**BOWERS ELEMENTARY SCHOOL
MANCHESTER, CONNECTICUT
STATE PROJECT NO. 077-0239 RNV
ADDENDUM NO. 7
March 2, 2022**

I. REVISIONS TO SPECIFICATIONS

A4.01

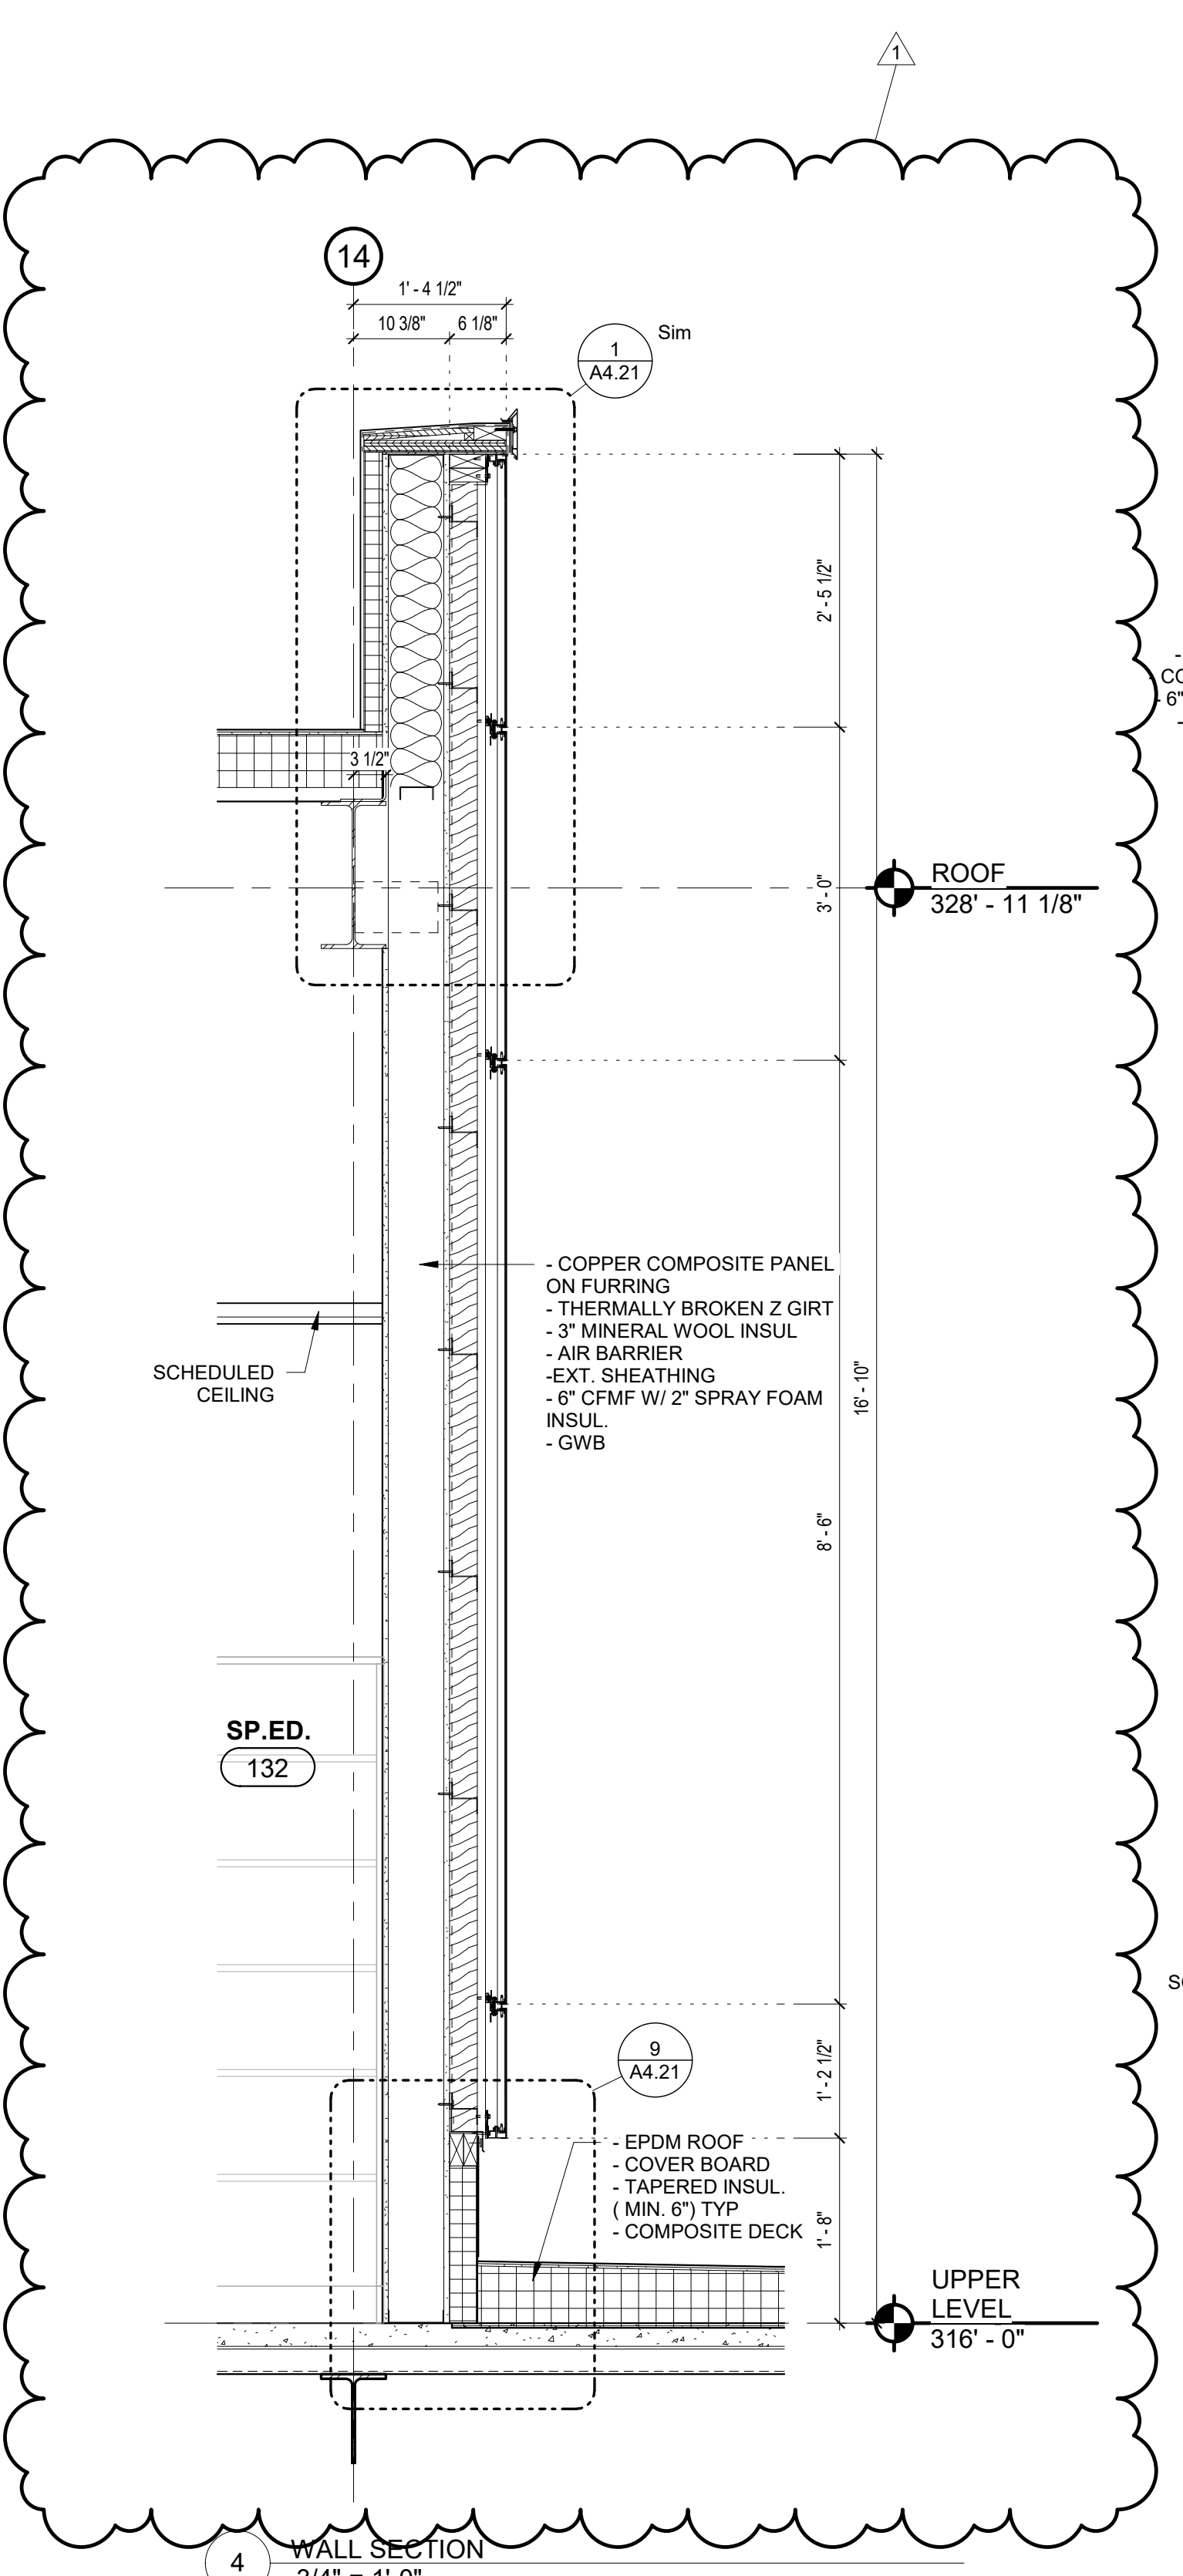
7. A4.01;
- Replace sheet with attached A4.01.
8. A4.21;
- Replace sheet with attached A4.21.
9. A4.22
- Detail 4; Refer to revised sketch PB_SKA-05R
10. A4.24
- Detail 2; Refer to revised sketch PB_SKA-05R
11. A4.31;
- Replace sheet with attached A4.31.
